SUBMITTAL TRANSMITTAL

Submittal No: 05500-009.A

PROJECT: **Harold Thompson Regional WRF**
Birdsall Rd.
Fountain, CO 80817
Job No. 2908

SUBJECT: Re-submittal for the Aeration Basin/Digester Stairs

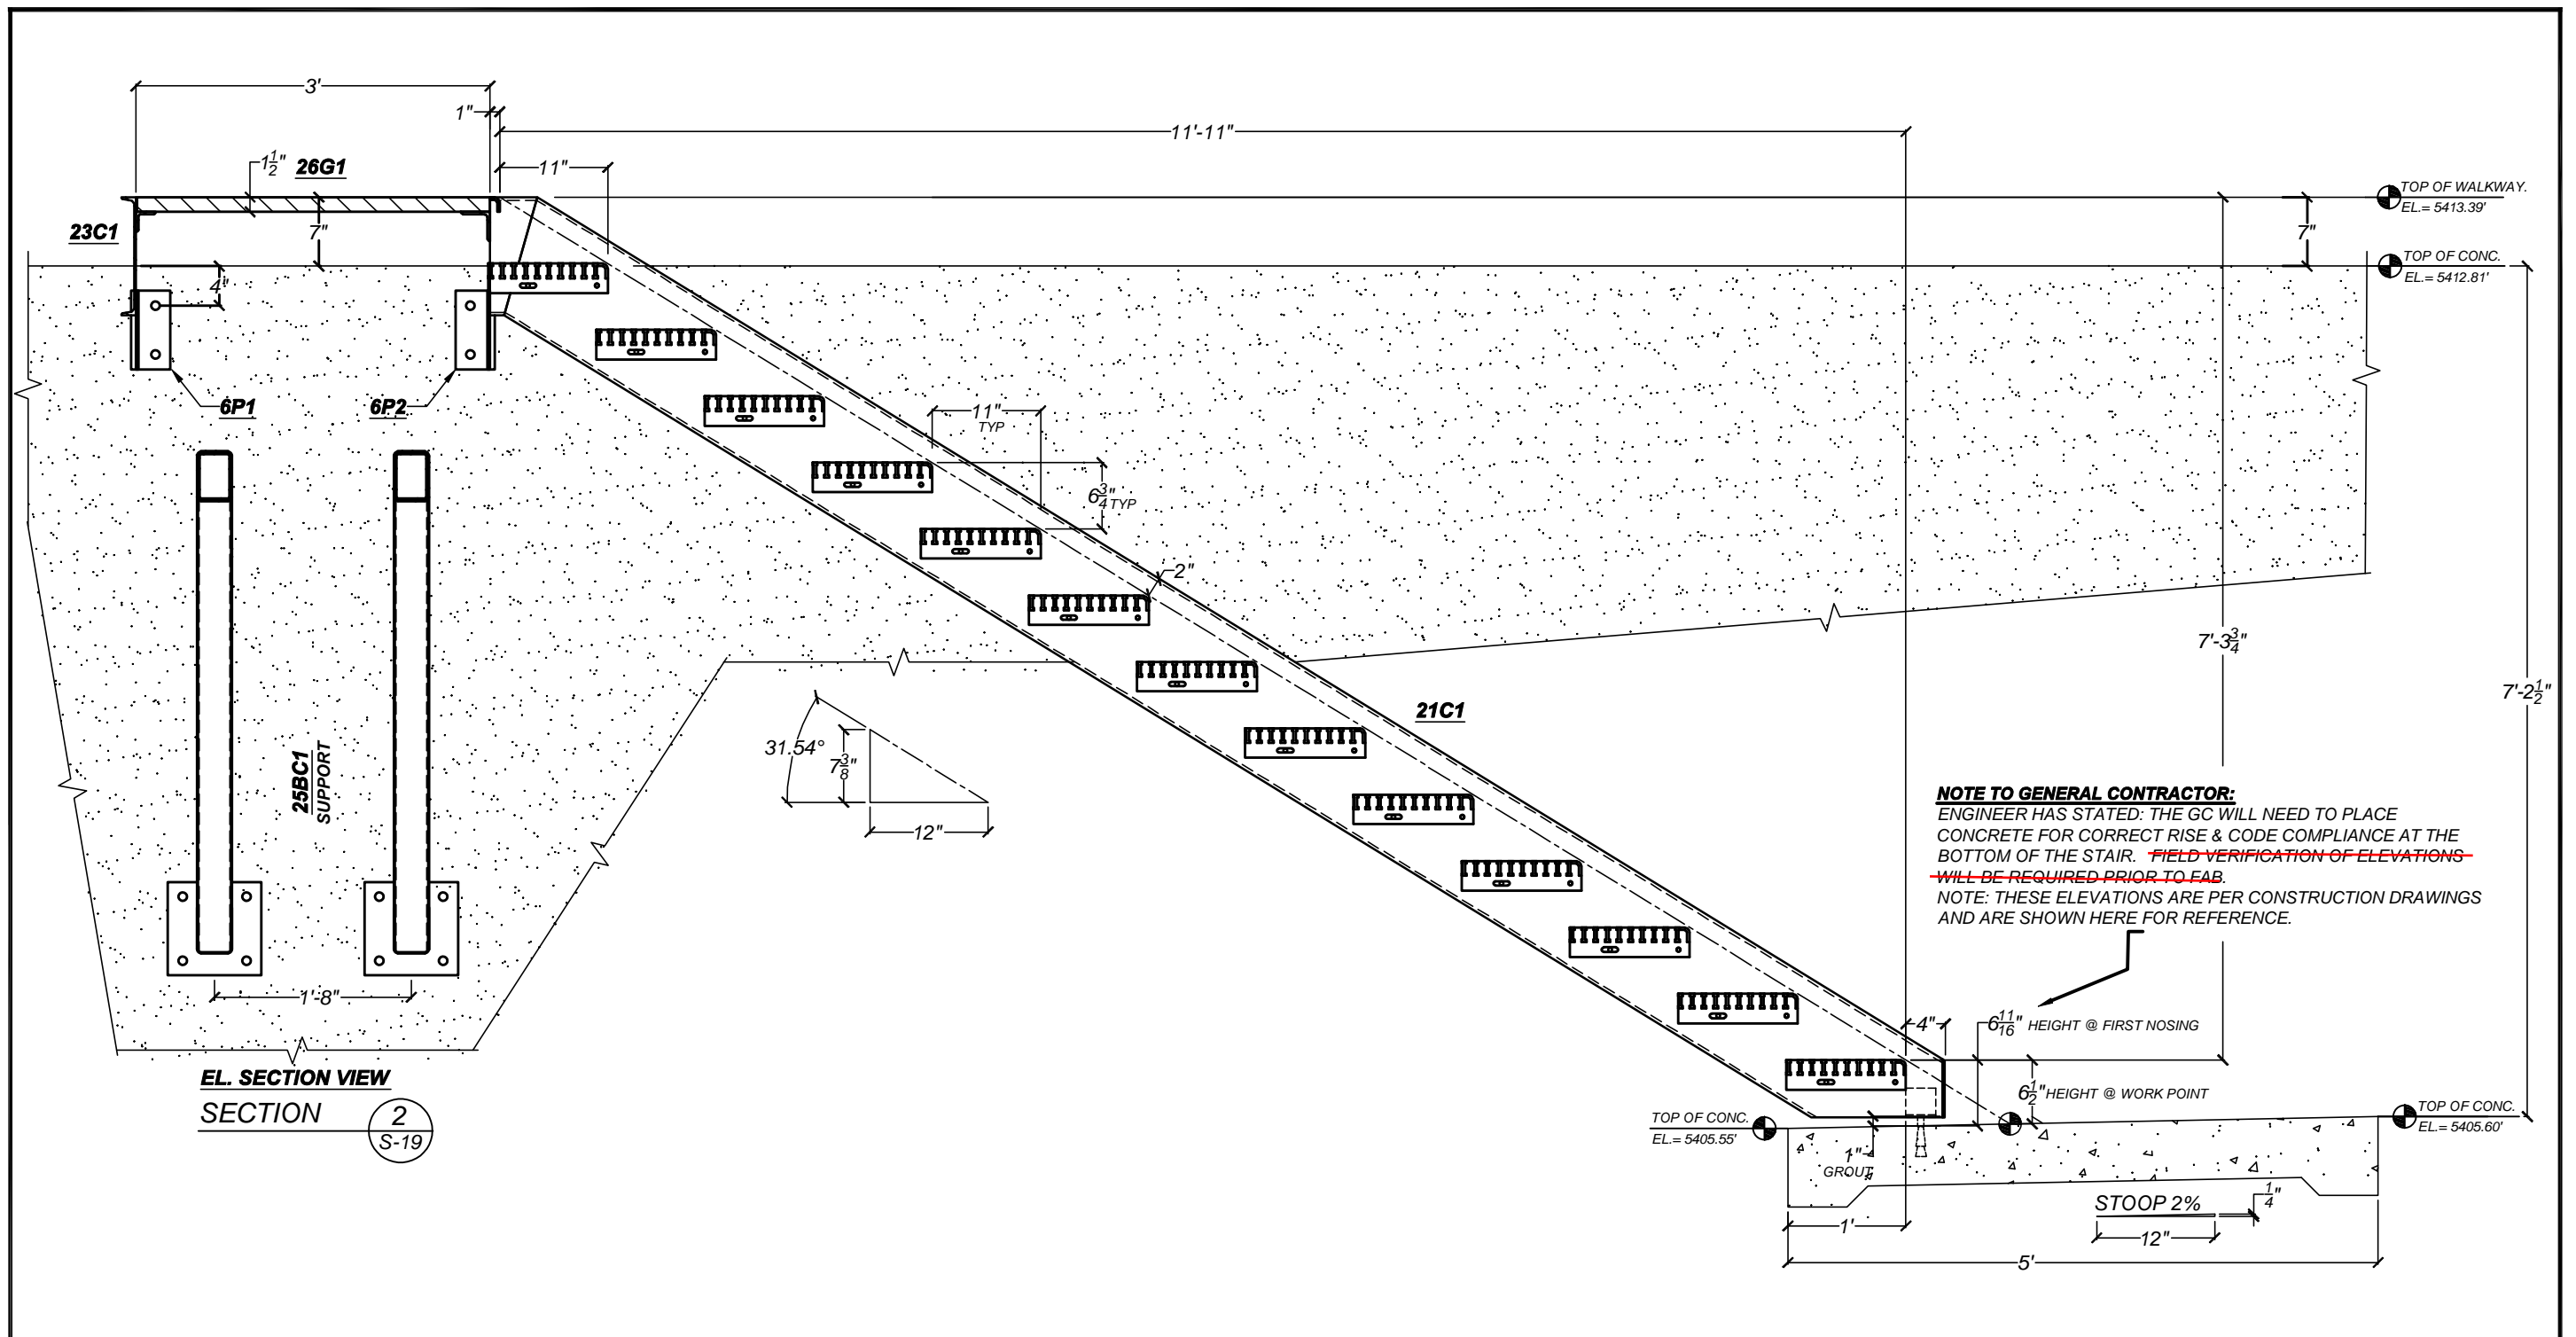
15. Sheet S-19: **Make Corrections Noted** Changed per this document & added note.
 - a. The plan view of the stair indicates 1½-inch aluminum I-bar non-slip treads will be utilized. All stair treads must be serrated aluminum tread. This also applies to the elevation section view.

- b. The fabricator has provided a note on the drawings indicating the Engineer to verify the downhill elevation of the stoop. We request the fabricator work with the General Contractor as the Contractor is ordering the stairs and placing the concrete. The General Contractor must provide all necessary as-constructed elevations needed by the fabricator.

NOTE TO GENERAL CONTRACTOR:
ENGINEER HAS STATED: THE GC WILL NEED TO PLACE CONCRETE FOR CORRECT RISE & CODE COMPLIANCE AT THE BOTTOM OF THE STAIR. ~~FIELD VERIFICATION OF ELEVATIONS WILL BE REQUIRED PRIOR TO FAB.~~
NOTE: THESE ELEVATIONS ARE PER CONSTRUCTION DRAWINGS AND ARE SHOWN HERE FOR REFERENCE.

Project	HAROLD D. THOMPSON REGIONAL RECLAMATION FACILITY	Date	1/23/2012
Area	LOWER FOUNTAIN METROPOLITAN SEWEGE DISPOSAL DISTRICT	Drwn By	DWN
Detail	DETAILS --- STAIRS PER 1/AB-9	Rev: 2	Date: 3/21/2012
Ref Dwg	NOTED	Scale	NONE
Sheet	S-27

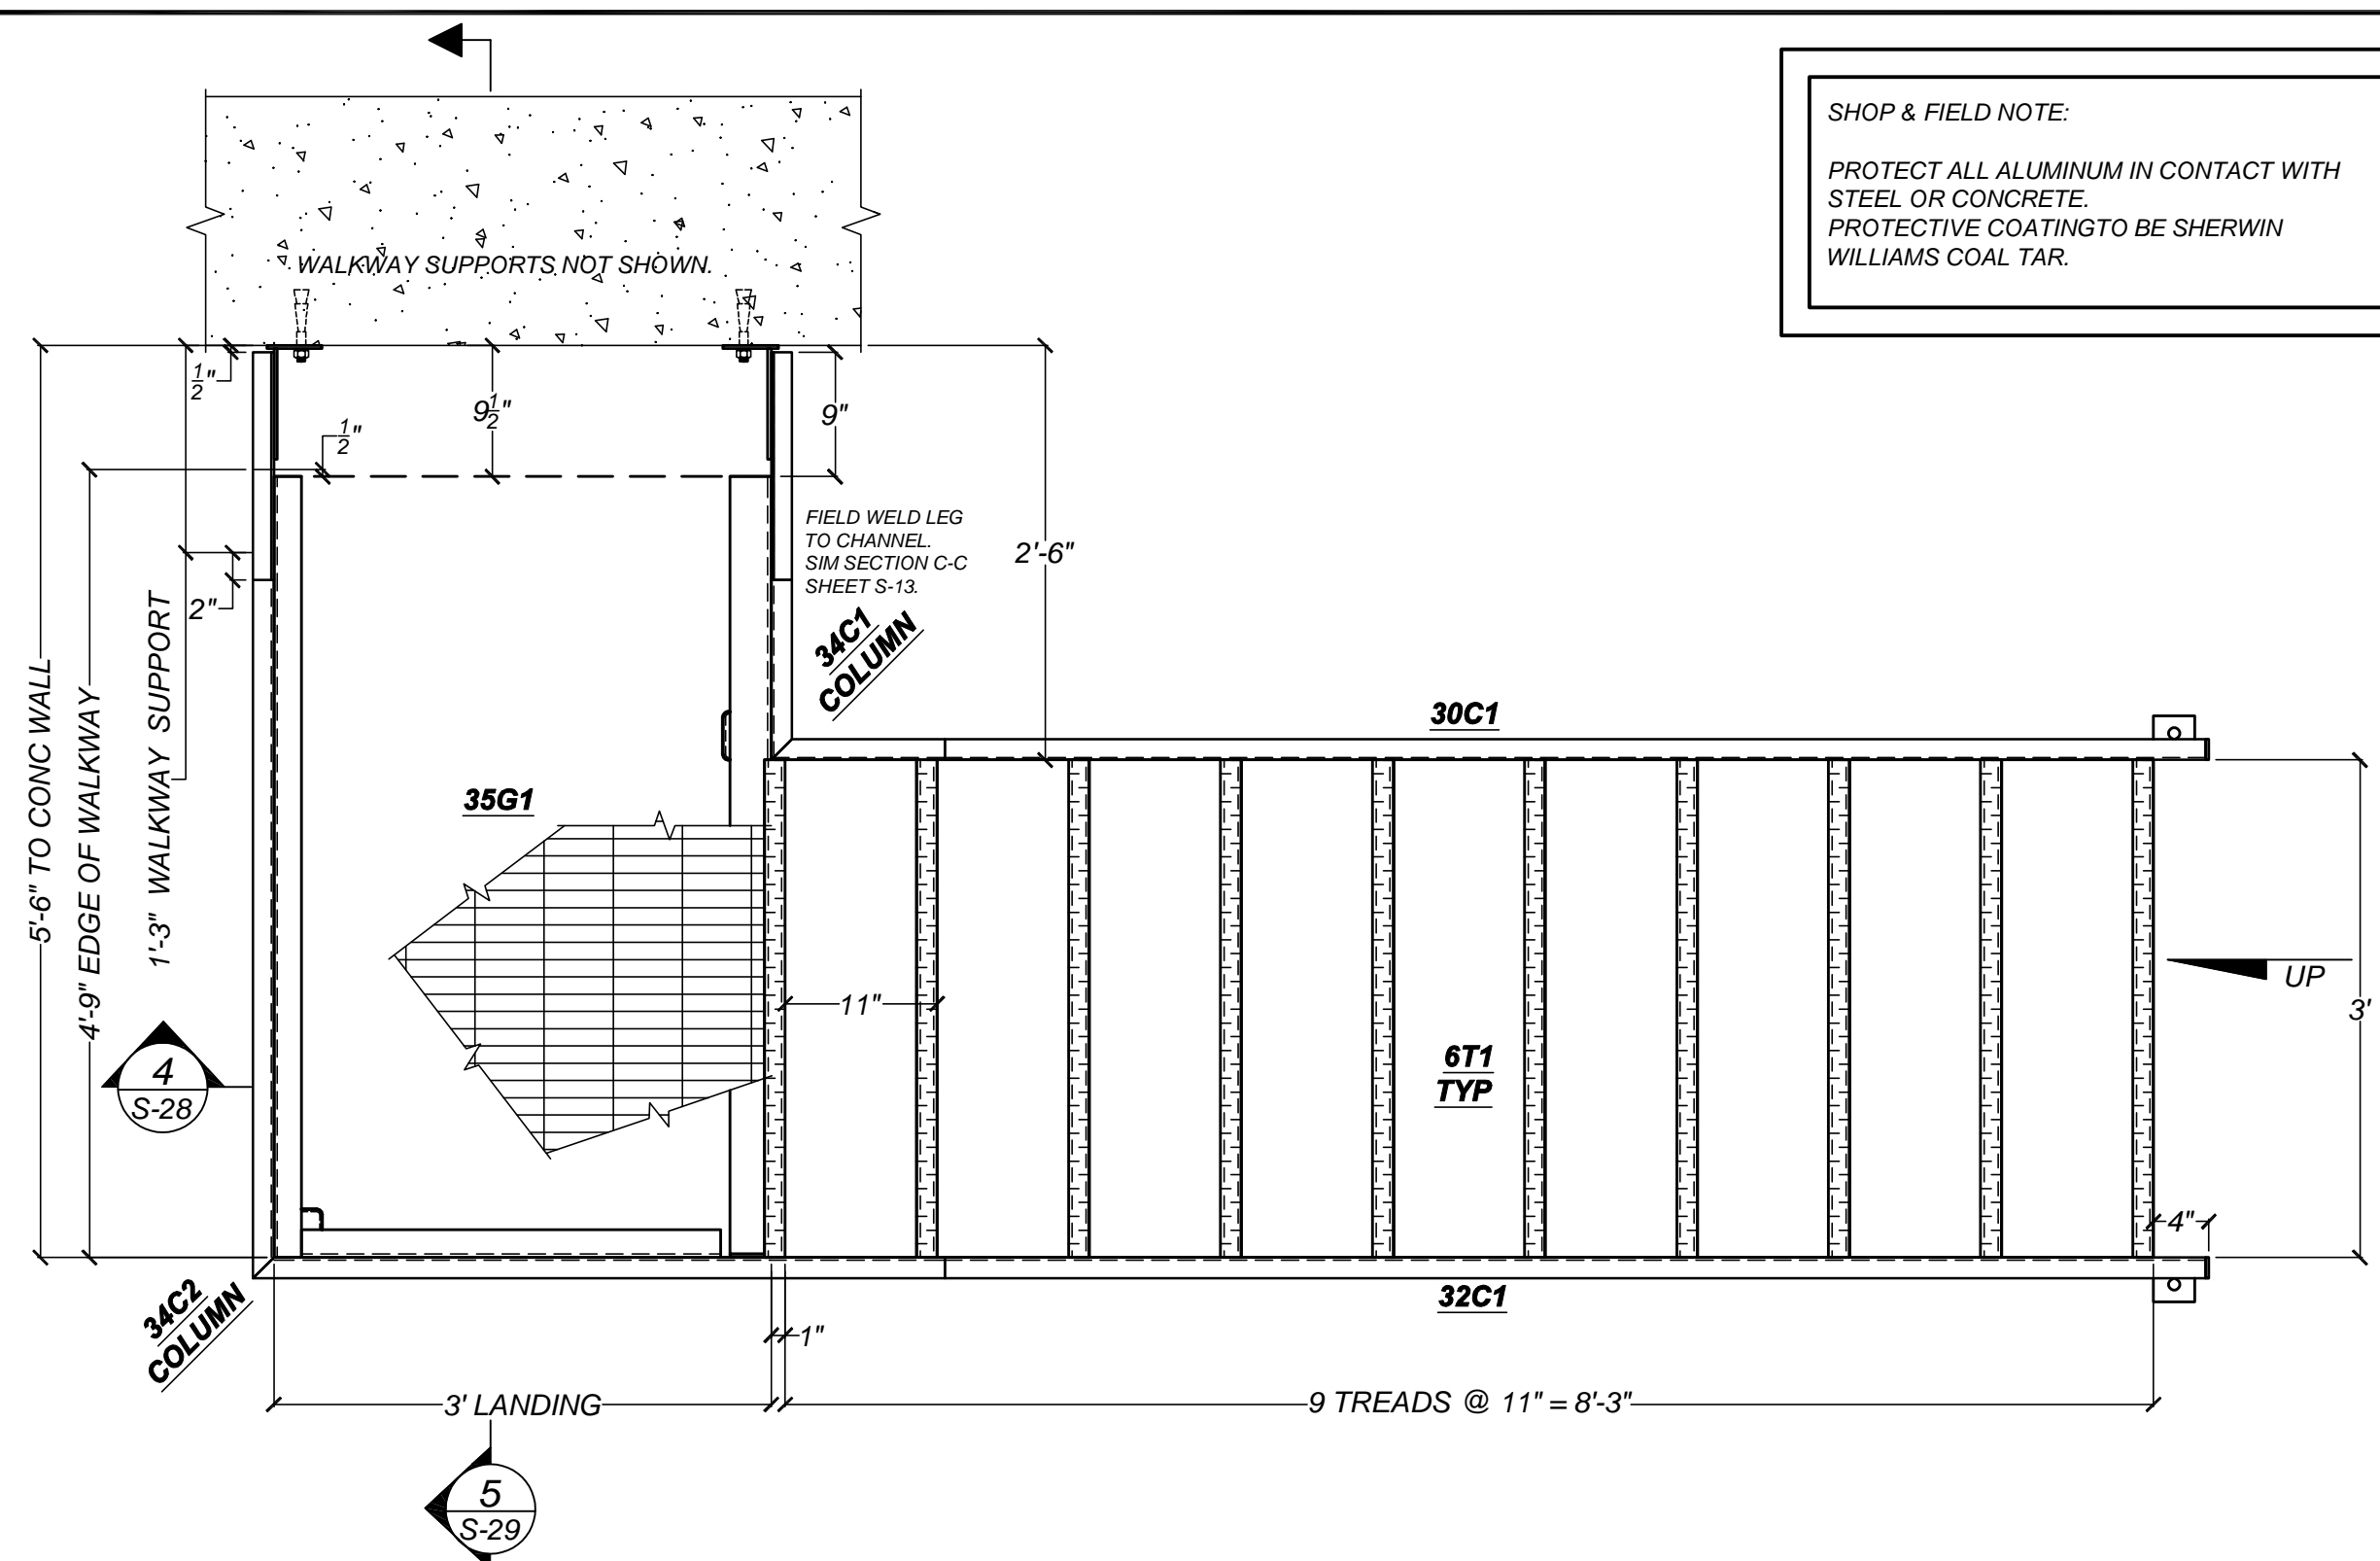
- a. The plan view of the stair indicates 1½-inch aluminum I-bar non-slip treads will be utilized. All stair treads must be serrated aluminum tread. This also applies to the elevation section view.

Project	HAROLD D. THOMPSON REGIONAL RECLAMATION FACILITY	Date	1/23/2012
Area	LOWER FOUNTAIN METROPOLITAN SEWEGE DISPOSAL DISTRICT	Drwn By	DWN
Detail	DETAILS --- STAIRS PER 1/AB-9	Rev: 2	Date: 3/21/2012
Ref Dwg	NOTED	Scale	NONE
Sheet	S-28

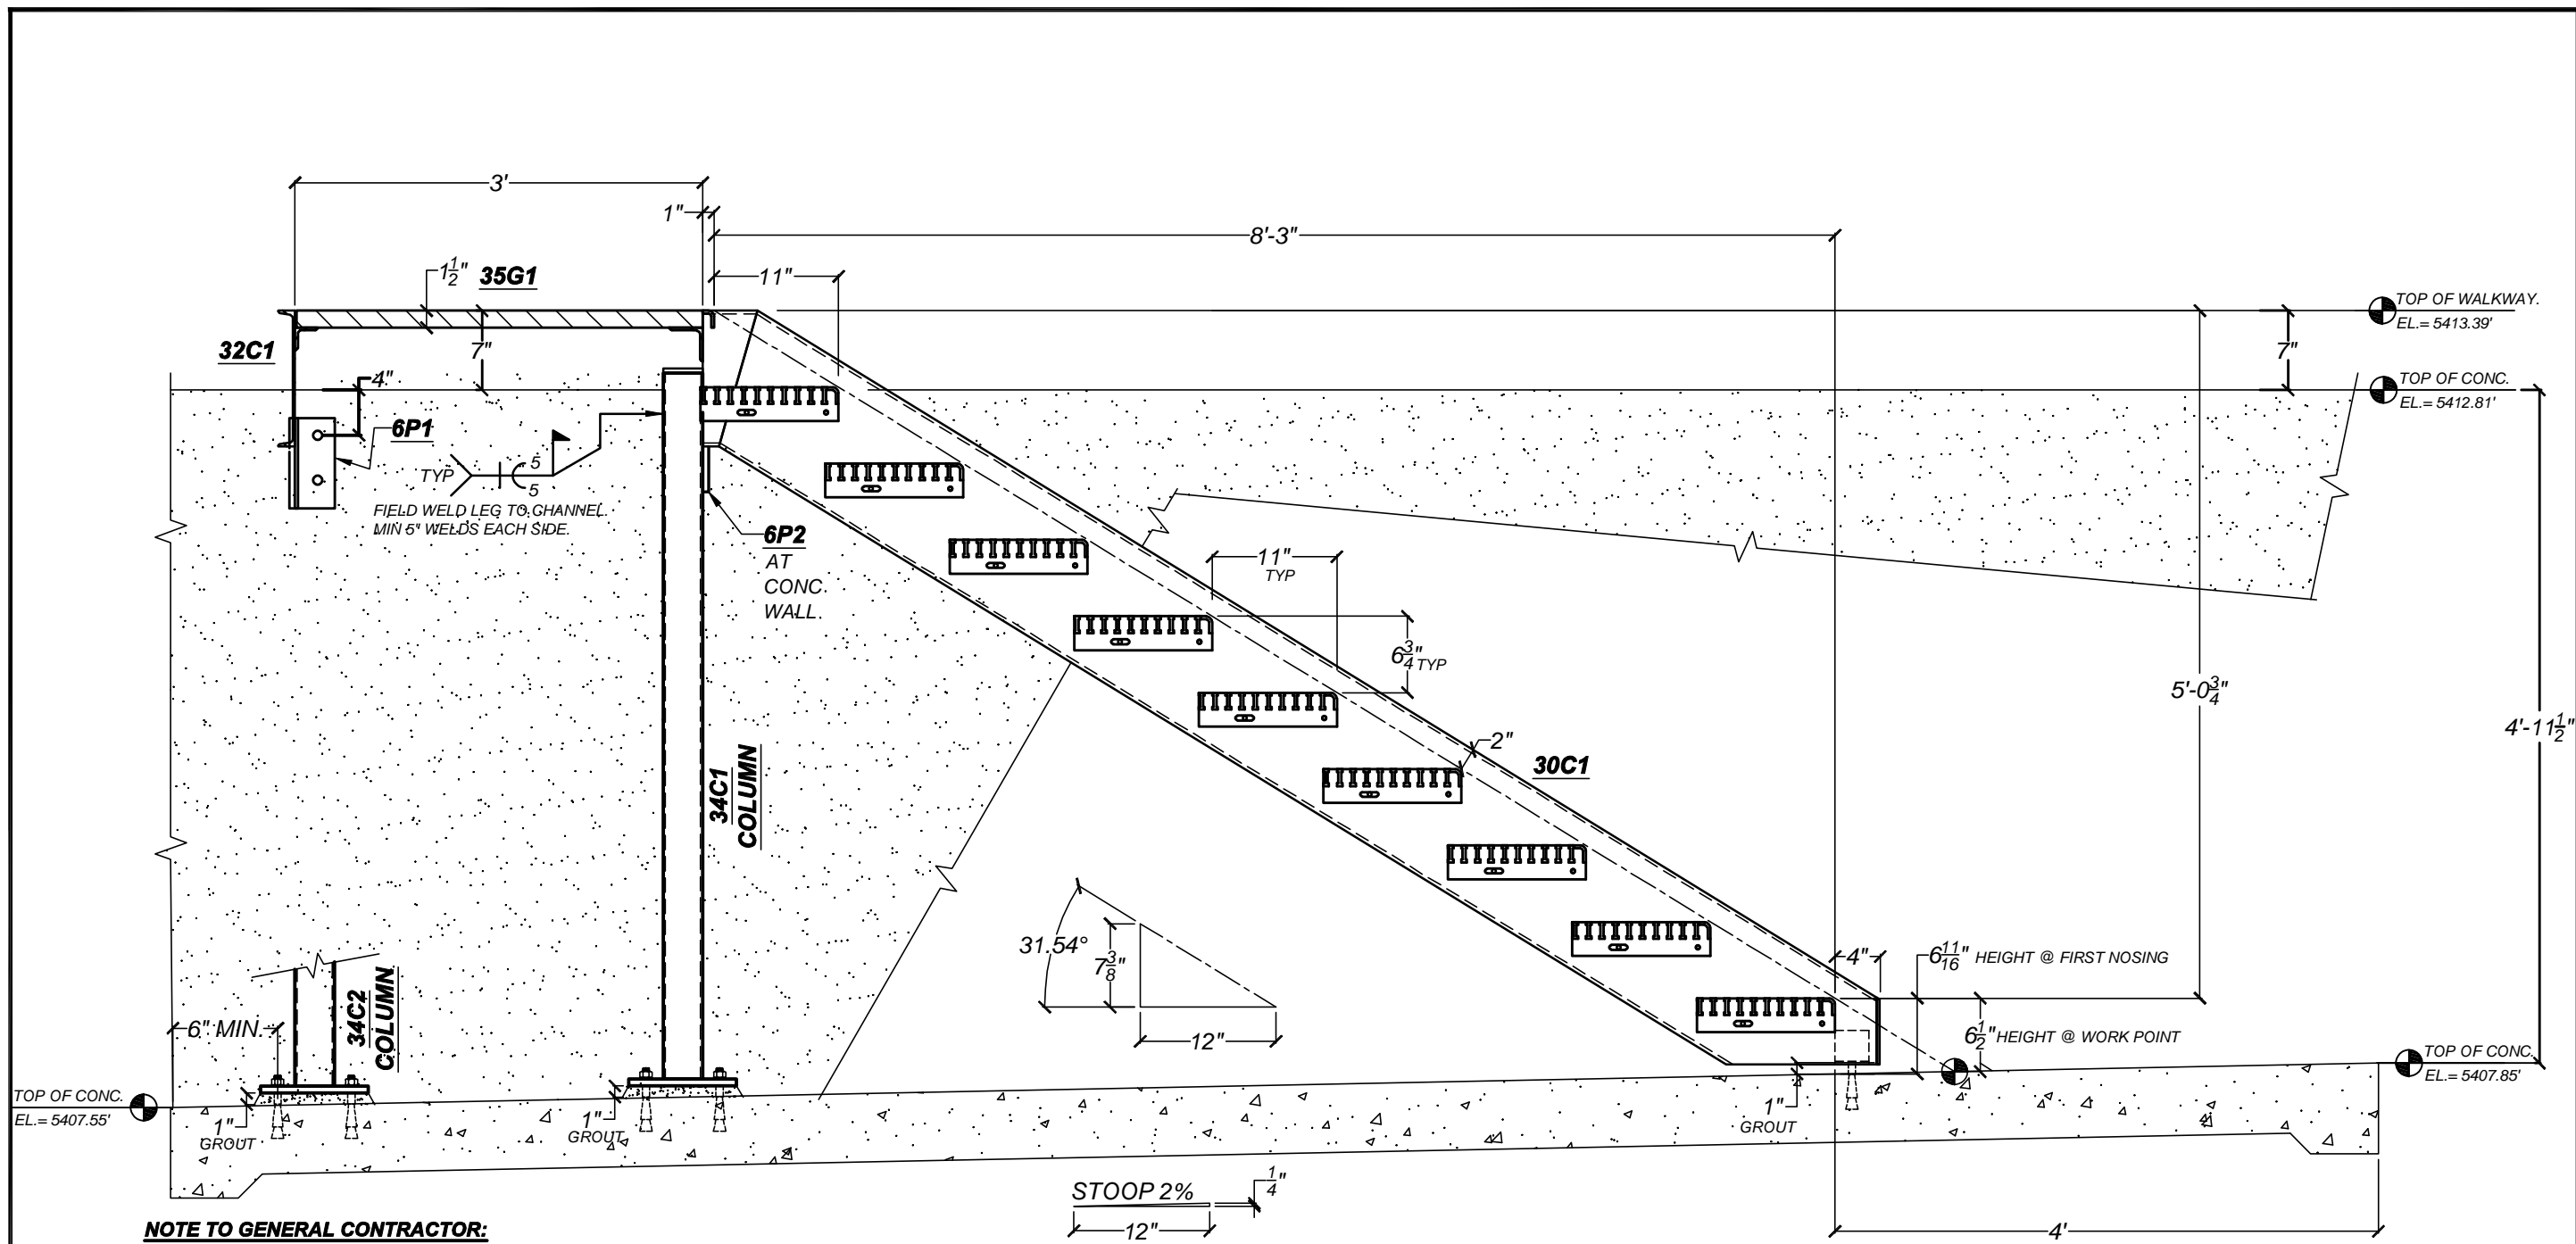
24. Sheet S-28: **Revise and Resubmit** Changed per this document & moved 6P1.
 - a. The plan view of the stair indicates 1½-inch aluminum I-bar non-slip treads will be utilized. All stair treads must be serrated aluminum tread. This also applies to the elevation section view.

- b. The concrete pad under the stairway and top landing is shown extending beyond the landing at the top of the stair. We request the Contractor modify the shop drawings and the details of the drawing shown on Sheet AB-9 to extend the concrete to 6 inches beyond the last anchor bolt.

NOTE TO GENERAL CONTRACTOR:
 ENGINEER HAS STATED: THE CONCRETE
 PAD MAY BE SHORTENED TO EXTEND MIN.
 OF 6" PAST THE LAST COLUMN ANCHOR.
